Re: Review of subsurface information proposed Greene Valley Landfill II, DuPage County, Illinois

EVALUATION OF PROPOSED 35 ACRE ADDITION
TO
GREENE VALLEY SANITARY LANDFILL
DU PAGE COUNTY, ILLINOIS

C. KUPFER, P.E., PRINCIPAL - SPACECO
&
D. O'BRIEN, JR., P.E., PRINCIPAL - O'BRIEN & ASSOCIATES, INC.

1. Emcon Geologic Sections showing alternate interpretation of soil profile
2. Patrick Excavation limits showing showing location of 10 soil borings
3. Testing Service Corp. log of boring 22 showing sand and gravel from 16.0' to 40.0'.

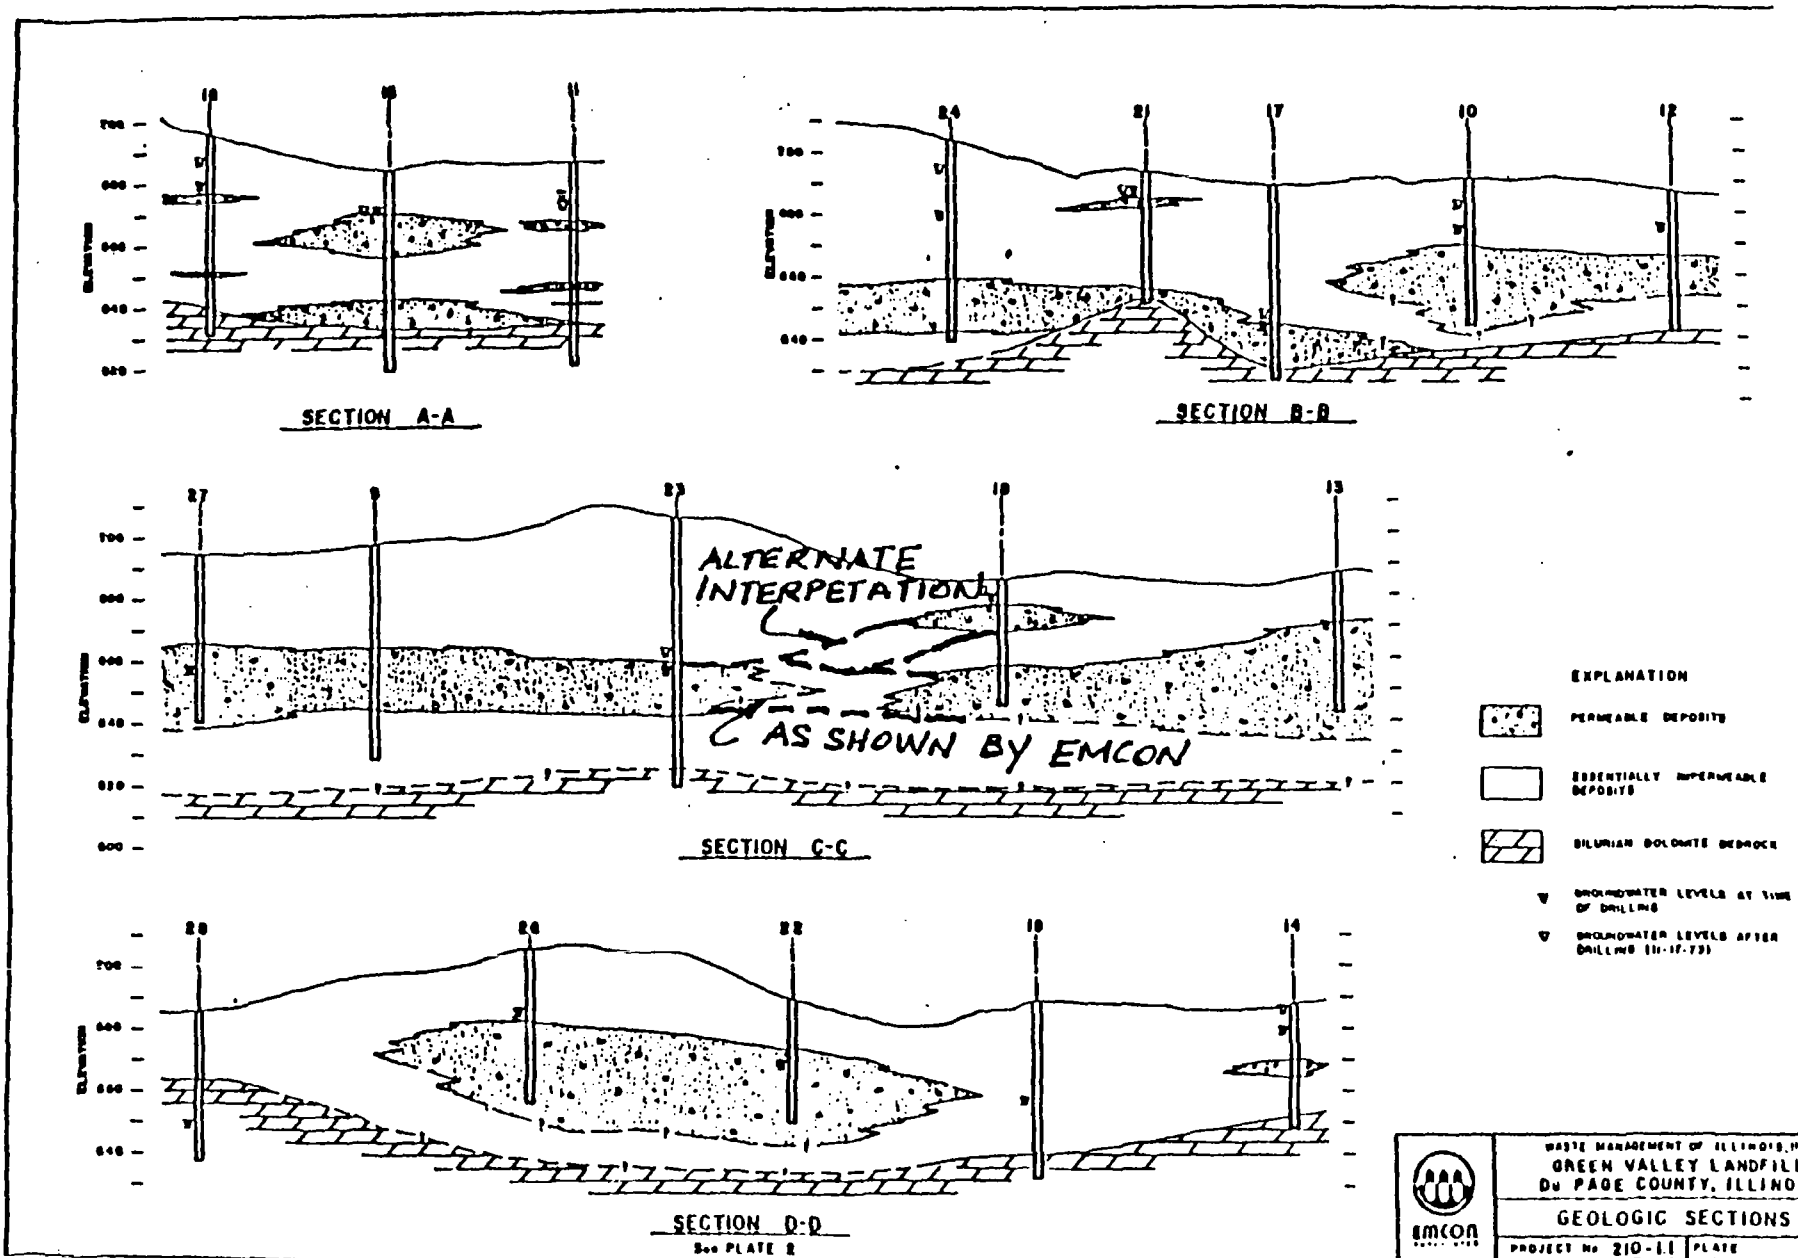
The sand and gravel deposits described in both the Emcon and Patrick reports represent permeable materials which would permit the migration of leachates and gases created in the landfill site off the property and, with the proximity of the east branch of the DuPage River to the proposed landfill site, to a major water course. Although it is indicated that the sand and gravel layers have limited lateral extent, boring 22 performed in the southwest corner of the proposed expansion area reveals sand and gravel materials from a depth of 16' below ground surface to the maximum depth of this boring, 40.0'. Also, although the Emcon report indicates that the sand and gravel deposits show a general absence of continuity, a review of their sections, particularly section CC, shows continuity of the sand and gravel deposit over the entire site.

MAP 2

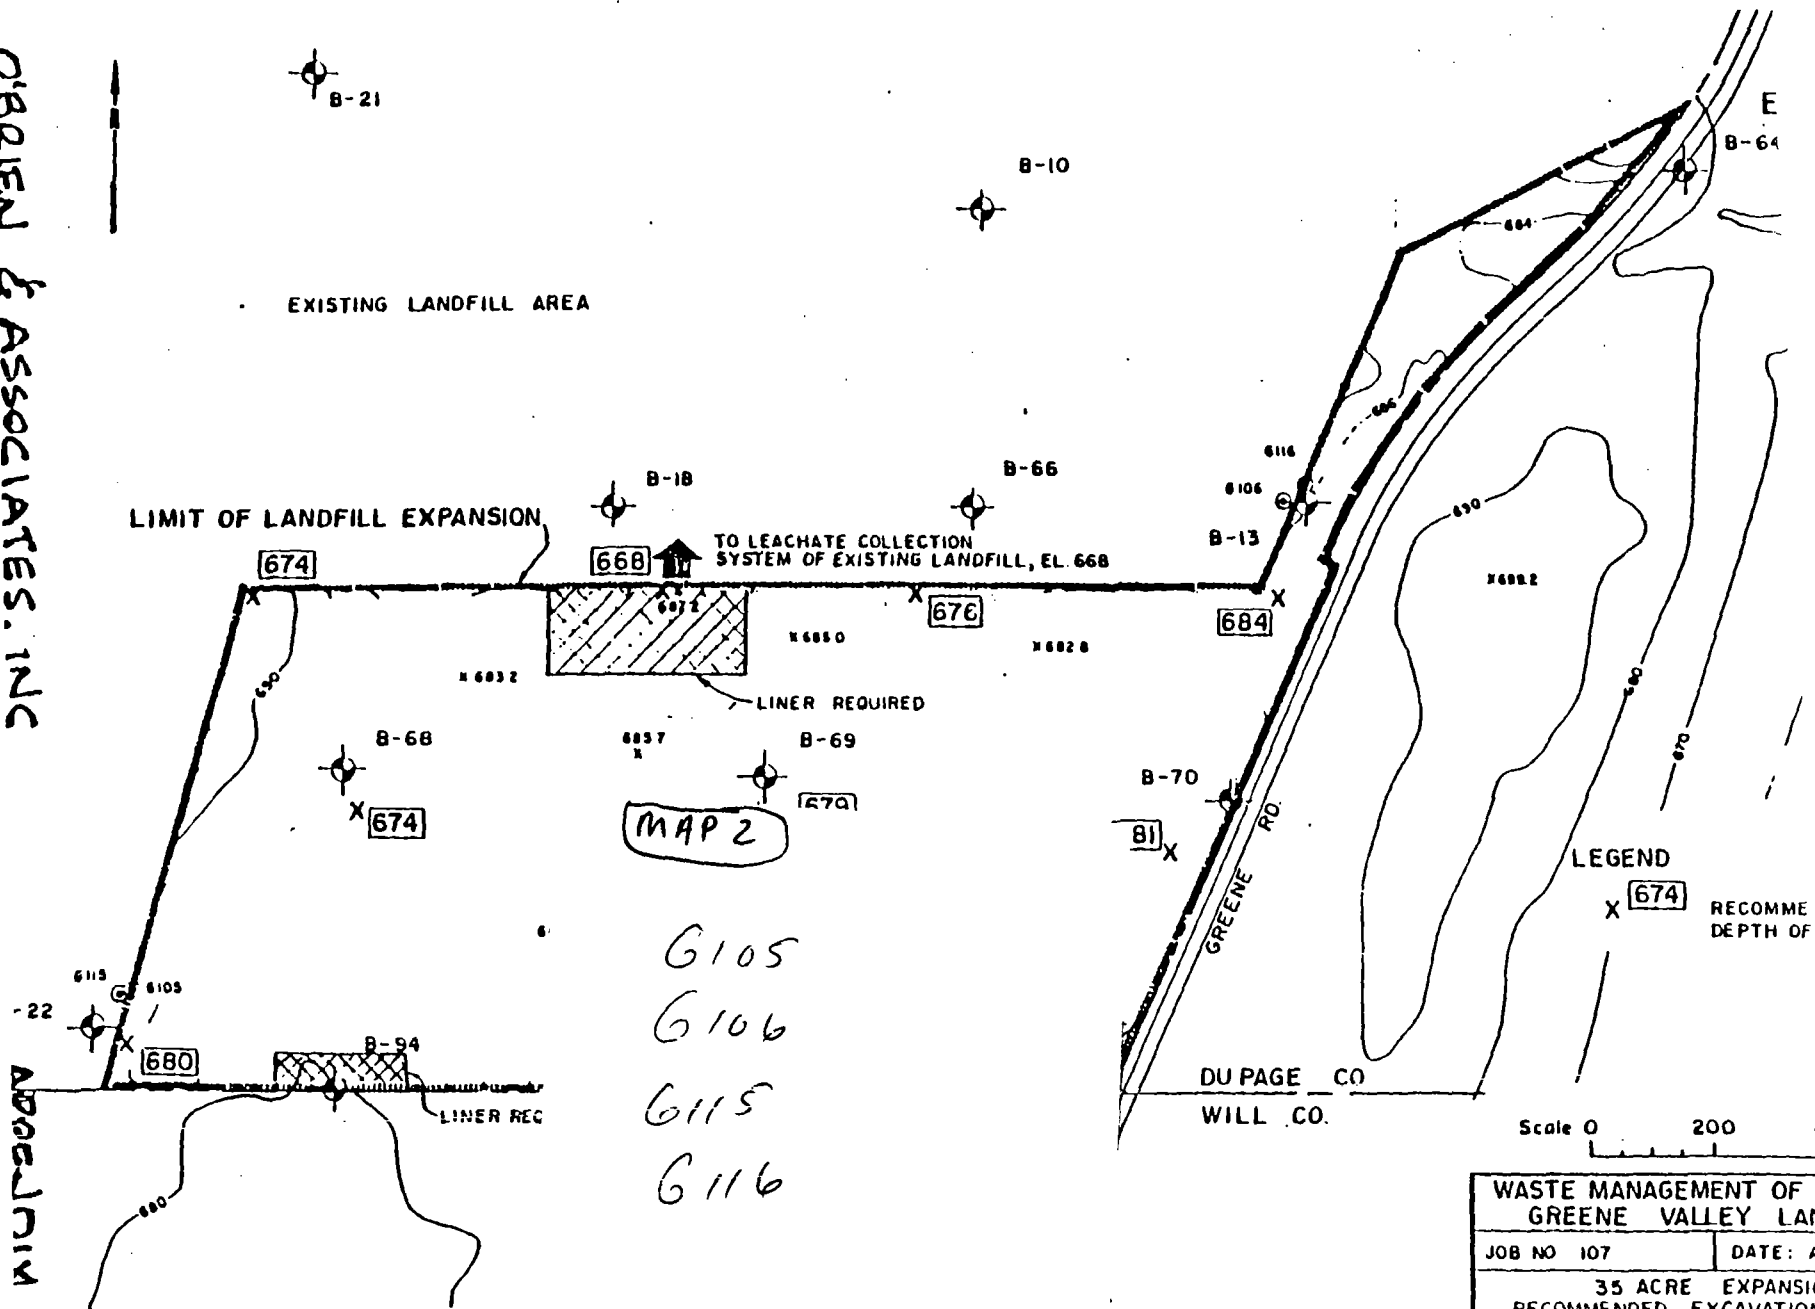
Our analysis of the design for the proposed landfill expansion indicates that bottom elevations have been established approximately as determined by Patrick Engineering Corp. from the 10 soil borings performed on the property. However, it is indicated by Patrick Engineering that additional exploration and testing should be performed and it would appear appropriate that, because of the extent of sand and gravel materials encountered, the additional soil borings should be performed prior to finalization of the design for the proposed landfill expansion. Also in the performance of any additional borings, continuous samples should be obtained to accurately establish the location and extent of the deposits of granular materials. In the borings performed to date, samples have been taken at 5' intervals with an average recovery of approximately 1' or less. This provides subsurface information on only approximately 20% of the soil profile and, where a thorough analysis of the location and extent of granular materials is required, data on 100% of the soil profile should be obtained at the boring locations. Also, in the performance of these borings, which will penetrate any clay material to the bedrock deposits providing well water to adjacent properties, grouting of the borings should be performed after their completion to assure that no migration of leachates and gases occurs through the open borings to the water well aquifer.
